Project	IEEE 802.16 Broadband Wireless Access Working Group < http://ieee802.org/16 >
Title	Clarification on carrier management
Date Submitted	2009-02-27
Source(s)	Hyunjeong Kang, Jaehee Cho hyunjeong.kang@samsung.com Samsung Electronics
Re:	Change request to the 802.16m SDD (section 19)
Abstract	This contribution proposes to clarify carrier management operation in 802.16m SDD.
Purpose	For review and discussion in 802.16m
Notice	<i>This document does not represent the agreed views of the IEEE 802.16 Working Group or any of its subgroups. It represents only the views of the participants listed in the "Source(s)" field above. It is offered as a basis for discussion. It is not binding on the contributor(s), who reserve(s) the right to add, amend or withdraw material contained herein.</i>
Release	The contributor grants a free, irrevocable license to the IEEE to incorporate material contained in this contribution, and any modifications thereof, in the creation of an IEEE Standards publication; to copyright in the IEEE's name any IEEE Standards publication even though it may include portions of this contribution; and at the IEEE's sole discretion to permit others to reproduce in whole or

Figure xxx. Relation between Available, ~~Assigned~~ and Active Carriers

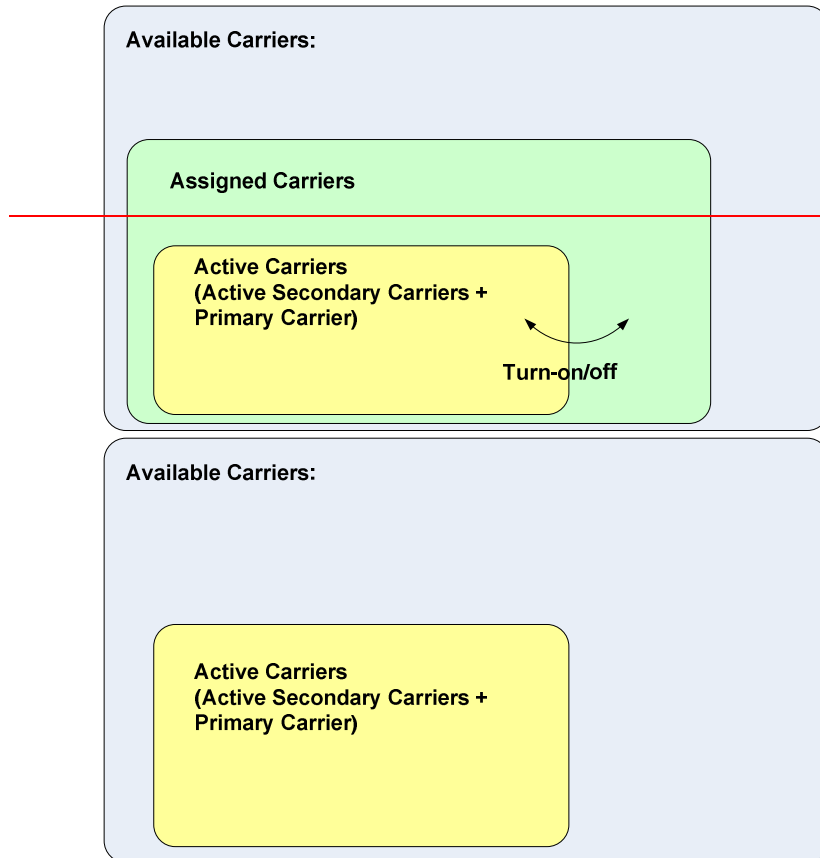
~~Based on AMS RF capabilities, loading of available carriers or other factors, the ABS may provide more detailed configuration information on subset of available carrier designated as Assigned Secondary Carriers to AMS. The AMS does not perform any PHY/MAC processing on Assigned Secondary Carriers until directed by the ABS.~~

4. The ABS allocates a subset of available assigned secondary carriers to be ready for the potential use for MC data transmission based on AMS RF capabilities, QoS requirement, loading and other factors. This subset is called the *Active Secondary Carriers*.
